Product Advisory

BOM component change only for supply continuity

BRCM Part Number	New Revision Number
BCM957504-P425G	21
BCM957454-P425SL2	10
BCM957454-P425SL2FRU	9

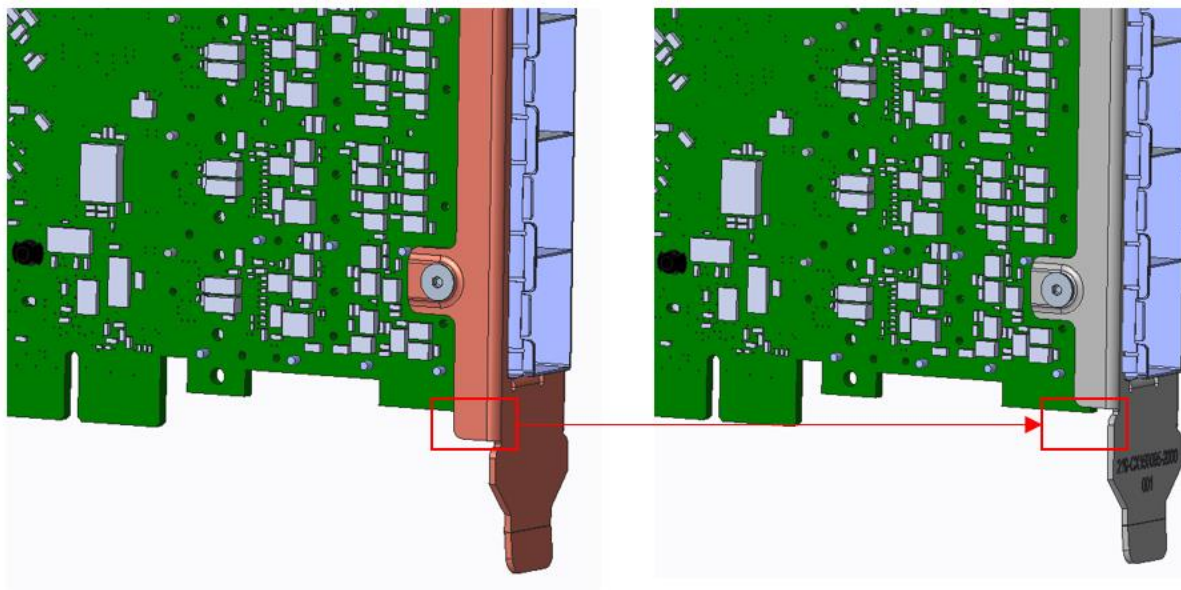
Minor modification to bracket flange

The full-height bracket for the P425 adapter (4 x 25G PCIe NIC) is being updated to correct a minor compliance issue. The current bracket, while fine for most system chassis, may have fitment issues in a small number of system chassis designs. This has been corrected by shortening the flange as shown in the following illustrations picture. The image on the left is the current bracket design with the flange extending below the PCB edge. The image on the right is the updated bracket design with the corrected dimension.
